## NEW MEXICO OIL CONSERVATION DIVISION

Re: Application to Amend Order No. NSL-7042  
Jicarilla Apache 102 No. 14M  
API No. (30-039-31193)  
Surface Location: 1310' FSL & 1482' FWL (Unit N)  
BHL (As Drilled): 606' FSL & 1958' FWL (Unit N)  
Section 9, T-26 North, R-4 West, NMPM,  
Rio Arriba County, New Mexico

**WELL LOCATION AND ACREAGE DEDICATION PLAT**

**Application to Amend NSL-7042**

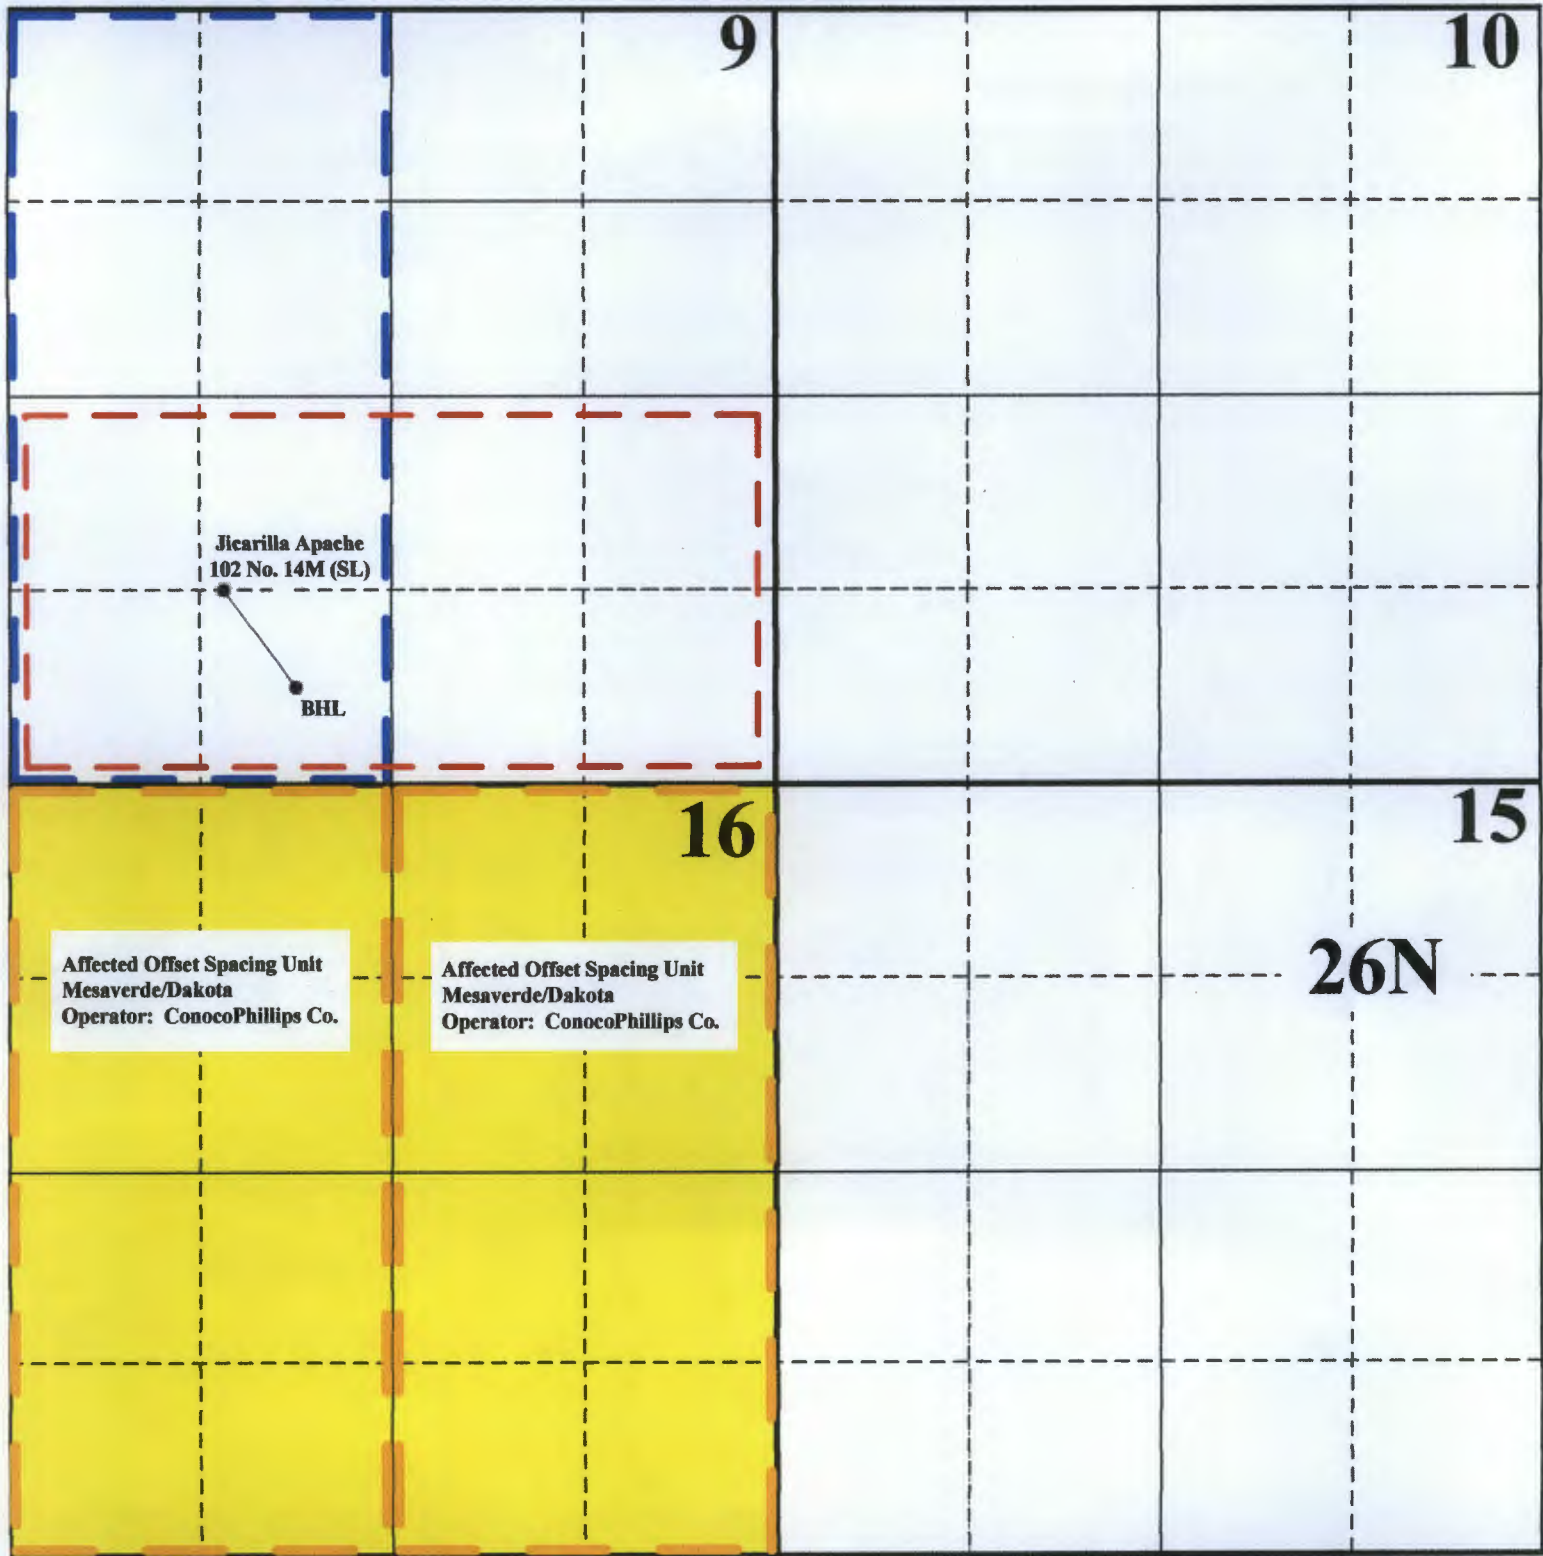
The C-102 that was submitted is the "as drilled" ? It did not clearly state this, and I will use this for the record.

The C-102 I submitted with the NSL application is not the "official" as drilled plat. However, this plat is accurate with regards to the surface and bottomhole locations of the well, as it was drilled.

I would think that for the purpose of the NSL application, this plat would be just fine to use.
